Environmental Impact Statement

Request for Project Change 4

Volume 3: Technical Reports

April 2019

Figure 9.7: Dutton Park Station Noise Barrier

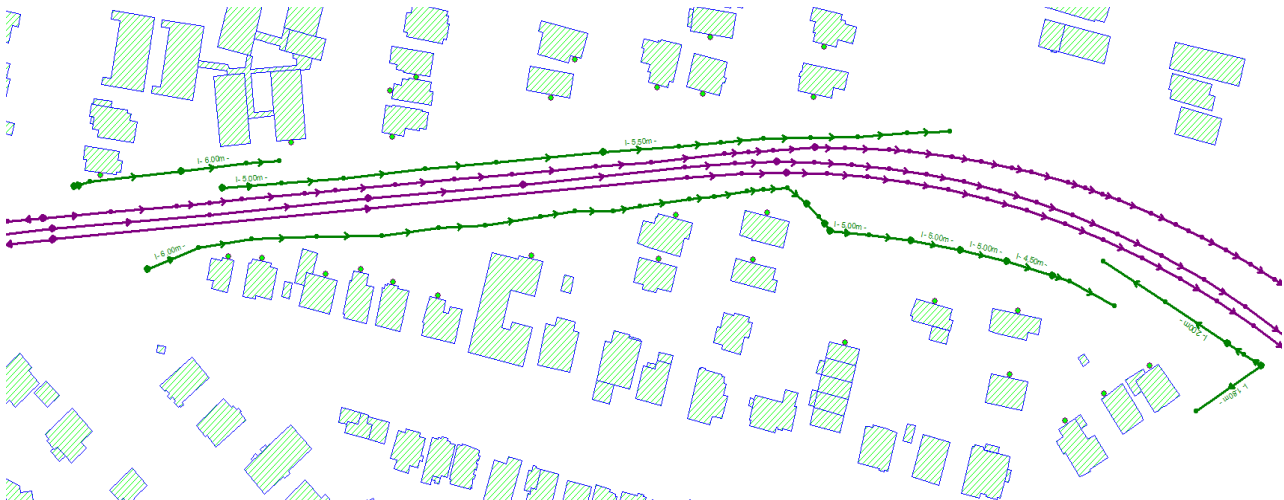
The existing noise barrier on the eastern side (Tamar, Cope and Samson Streets) will need to be increased to a minimum height of 6m in the majority of the barrier to 4.5m towards the proposed extended platform. The barrier would have a total length of 345m. The existing barrier on the western side also will need to be increased in height. The height would range from 5m to 6m, with a combined total length of 340m. This is shown in Figure 9.7 below.

Figure 9.8: Dutton Park Station Barrier - alternative

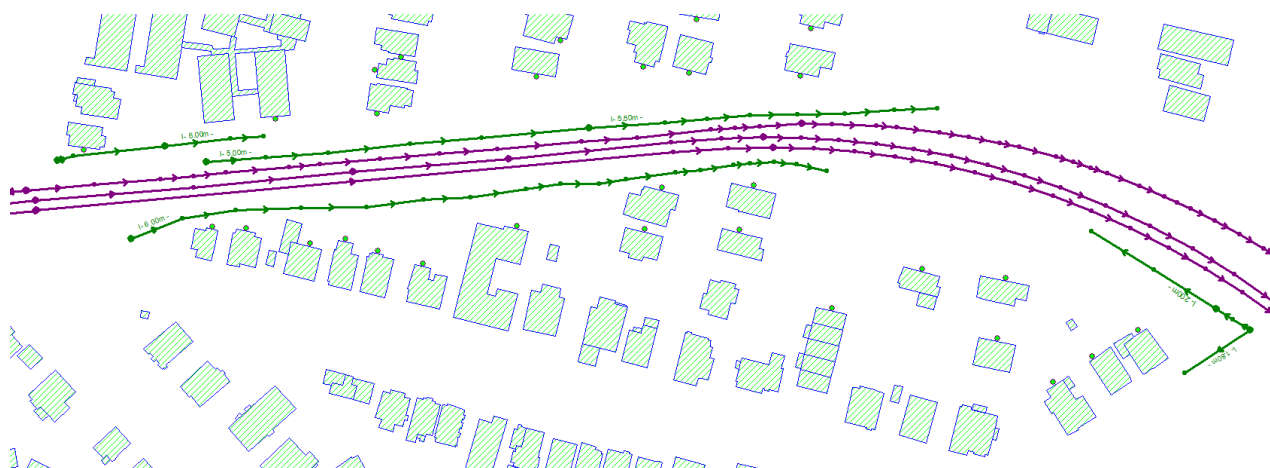
If the barrier described above is deemed to not comply with MD-15-317, a barrier with a section removed near the new platform has also been investigated. This is shown in Figure 9.8 below:

Figure 9.9: Required extent of noise barrier south of Yeronga Station

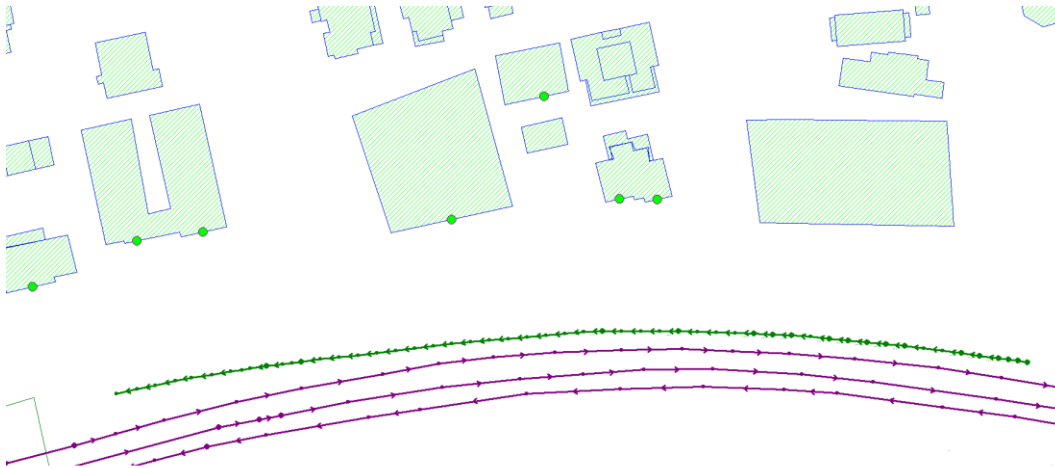
(from Nelson Street to Cook Street) would need to be extended to 200m, with a maximum height of 4.5m towards the south. With the extended barrier there would be no exceedances of criteria at this location. This is shown below in Figure 9.9.

Figure A1: Changes in traffic circulation routes for southbound traffic on Albert Street

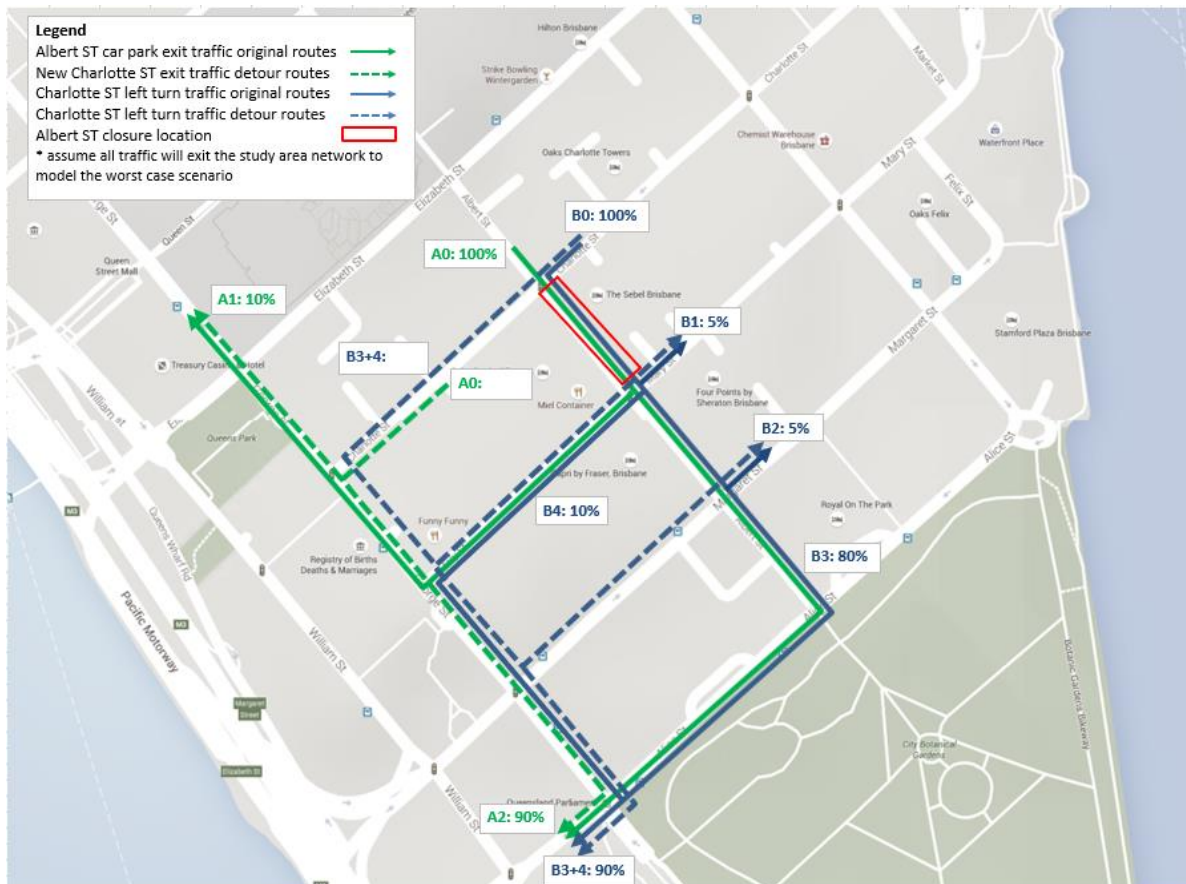
The same assumptions were made for this analysis with the exception that Albert Street between Elizabeth and Charlotte Streets will remain open and vehicles from the Myer car park on Albert Street will make a right turn into Charlotte Street. The right turn movement into Albert Street coming from Charlotte Street north will also remain. The changes to traffic circulation routes for the southbound and northbound traffic are illustrated in Figure A1 and Figure A2 respectively.

Figure A3: Intersection layout comparison of Albert and Charlotte Streets with & without the project

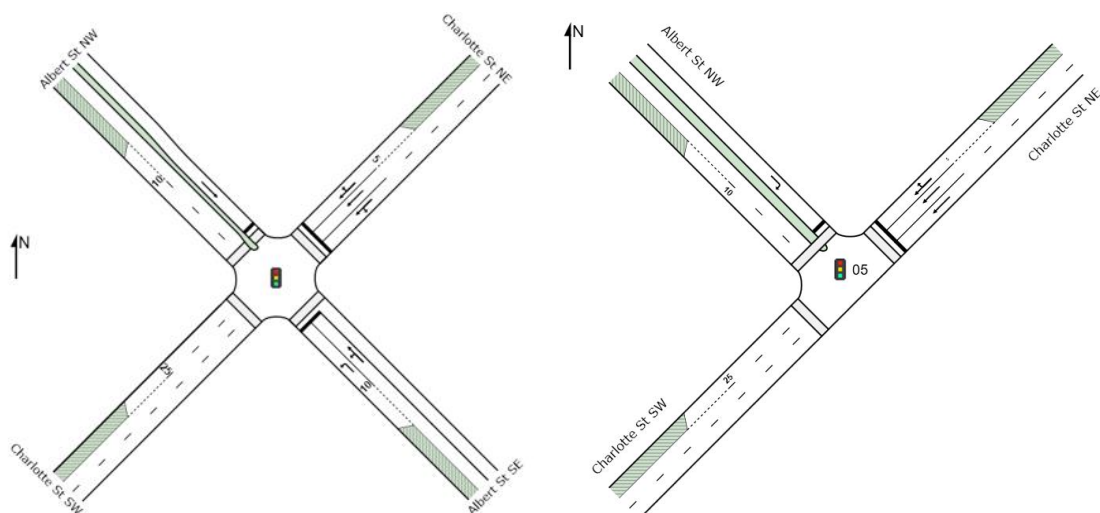
For this analysis, the same assumptions on signal cycle times and phasings were used for the intersections assessed.

Figure A5: Proposed works to Roma Street / Herschel Street

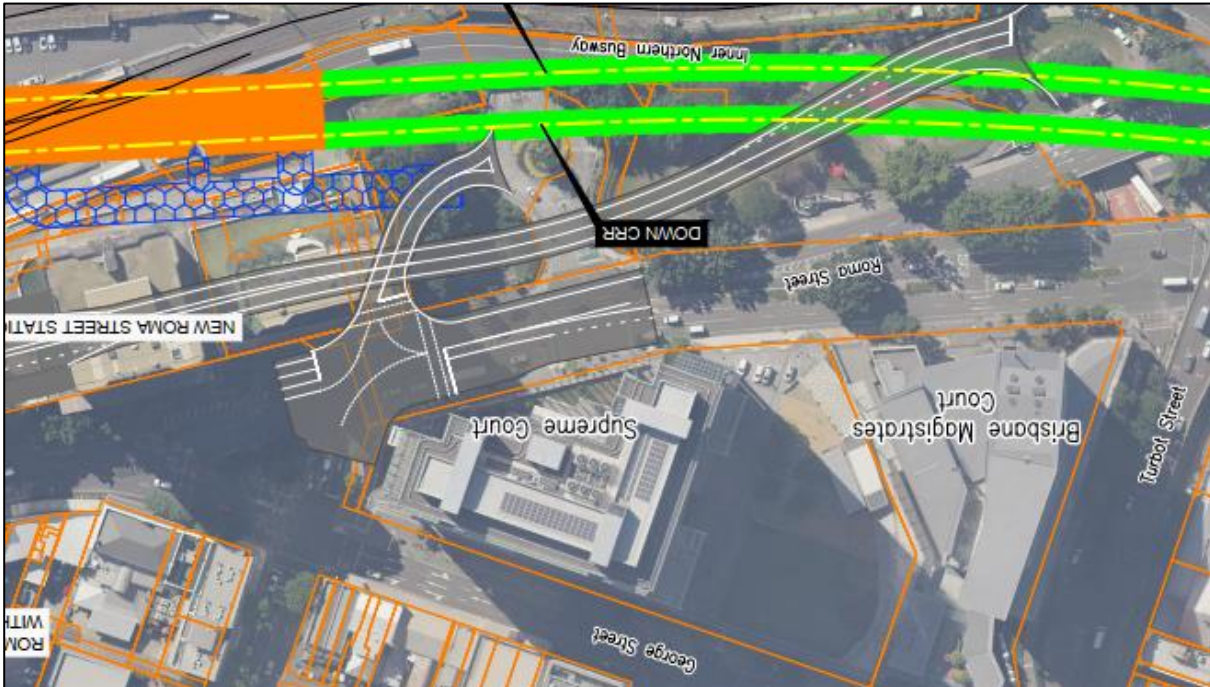
The extent of works proposed is primarily focused around the Roma Street / Herschel Street intersection and Roma Street / Parkland Boulevard intersection. The proposed design introduces a new approach to the Roma Street / Herschel Street intersection and closes the Parkland Boulevard intersection. The changes proposed is provided in Figure A5: below.

Figure A6: Roma Street / Herschel Street (Existing vs. Proposed)

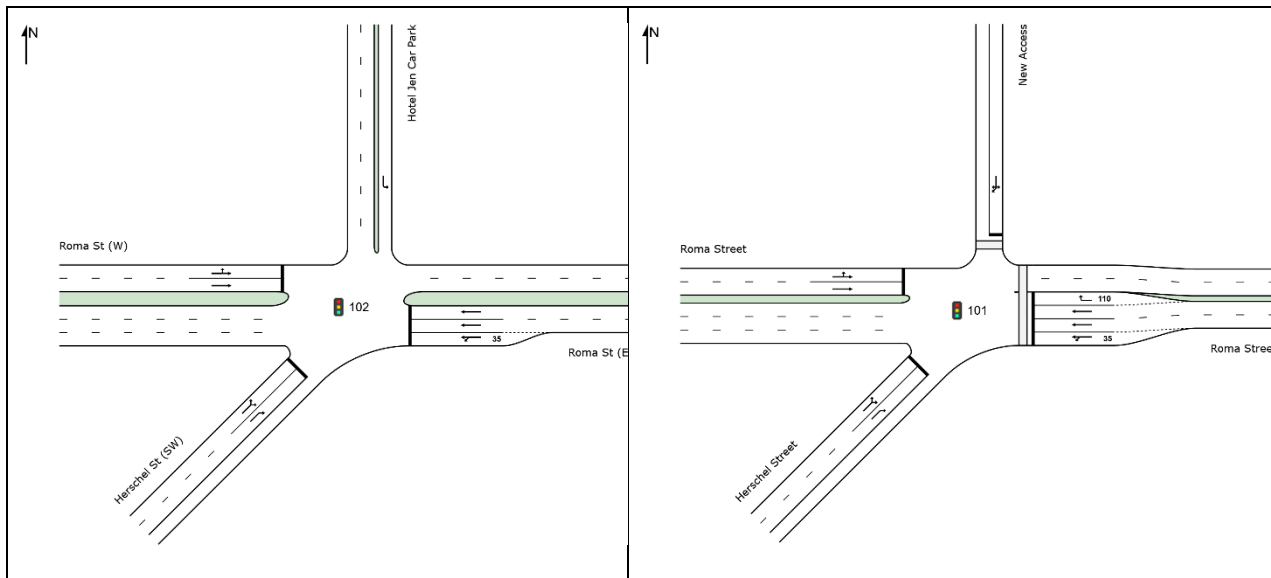
In the proposed design, the Hotel Jen Car Park access will be removed and will be converted into an access which ties into the existing roundabout along Parkland Boulevard. In addition to this, the existing median will be replaced with an additional turning lane to facilitate the turning movement from Roma Street into the new access. In addition to these changes, a pedestrian crossing will be introduced at the northern and eastern approach of this intersection. This is to facilitate pedestrian movements across Roma Street as the existing pedestrian overpass and the pedestrian crossings at the Parkland Boulevard intersection will be removed. As a result of this, the access to the Parkland Boulevard intersection will be closed off. An indicative SIDRA figure of the existing intersection and that in the proposed design is provided in Figure A6:.
